ENCLOSURE 2

Supplemental Historic and Cultural Resource Information

By letter dated May 12, 2016 (Reference 1), Tennessee Valley Authority (TVA) submitted an application for an early site permit for the Clinch River Nuclear (CRN) Site in Oak Ridge, TN. Subsequent to the submittal of the application, and consistent with interactions with NRC staff, TVA identified certain aspects of the application that it intends to supplement. By letter dated August 11, 2016 (Reference 2), TVA provided a plan for submitting the identified supplemental information.

The following markups reflect the revisions being made to ER Subsection 2.5.3 (including Table 2.5.3-1 and Figures 2.5.3-1, 2.5.3-2, and 2.5.3-3). Strikethrough text indicates deleted text. Underlined text indicates text added.

Figure 2.5.3-2.

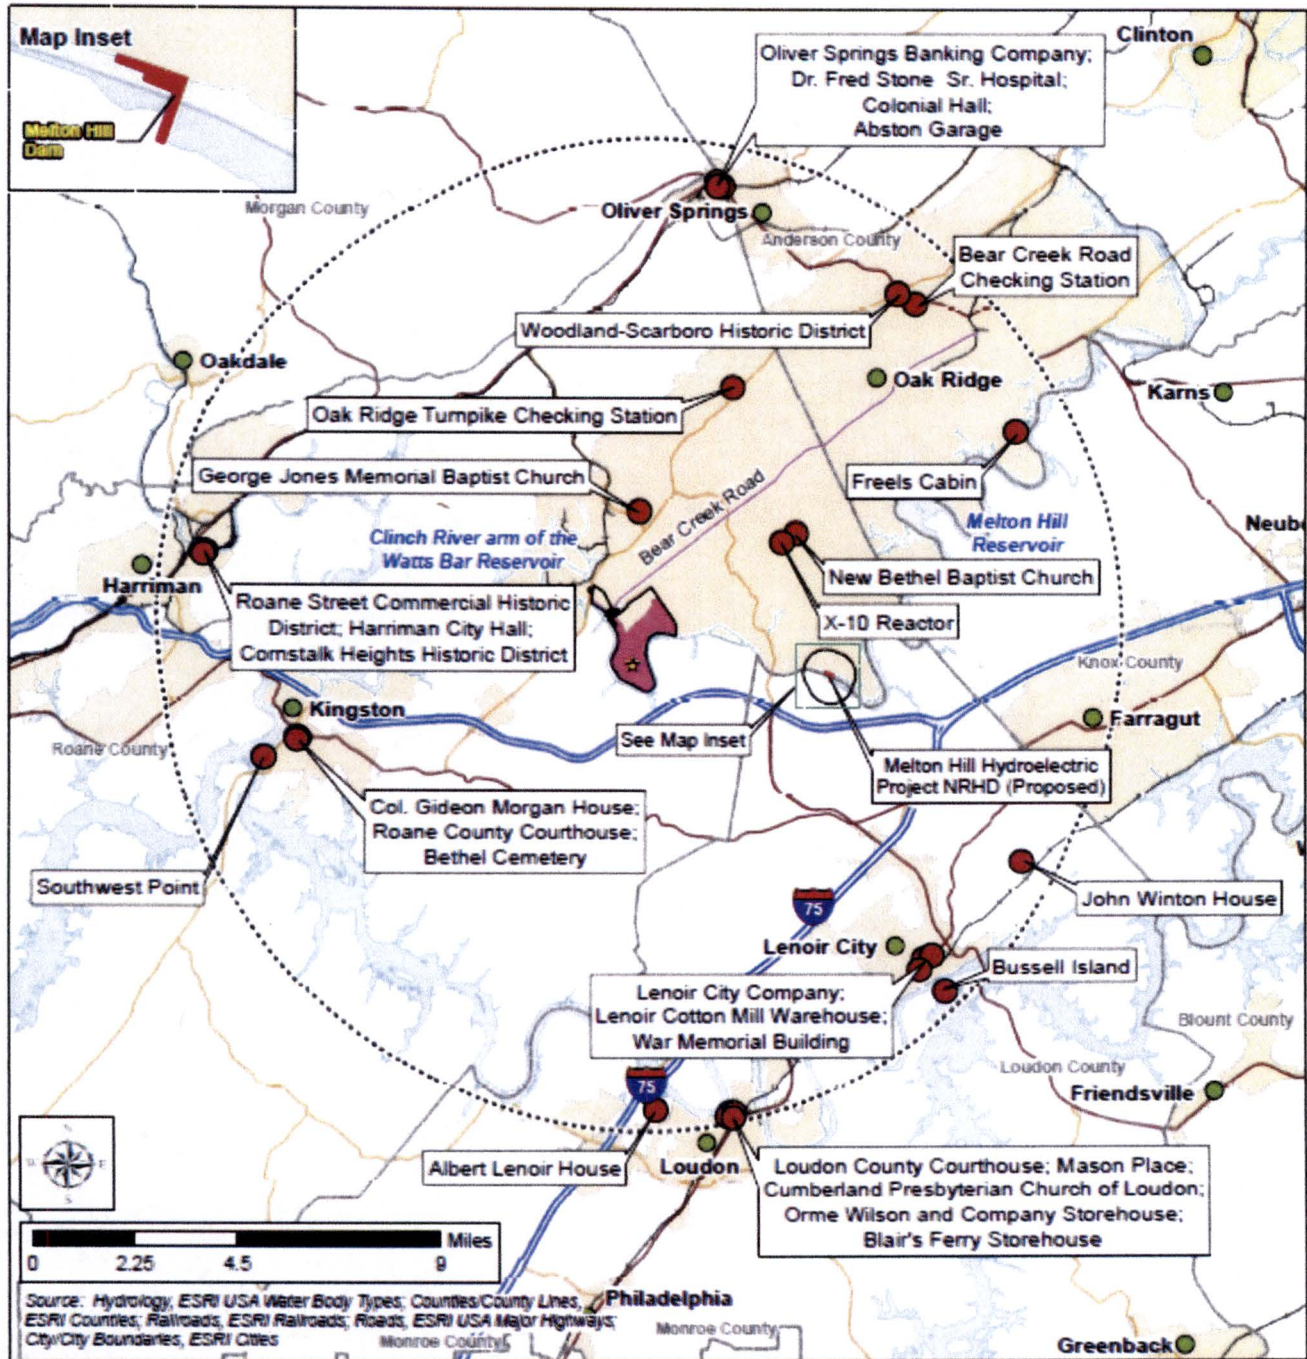
The APE shown on ER Figure 2.5.3-2 is being modified to include the Melton Hill Dam portions of the APE, and the legends on ER Figures 2.5.3-1 and 2.5.3-3 are being modified to clarify the portion of the APE shown on each figure.
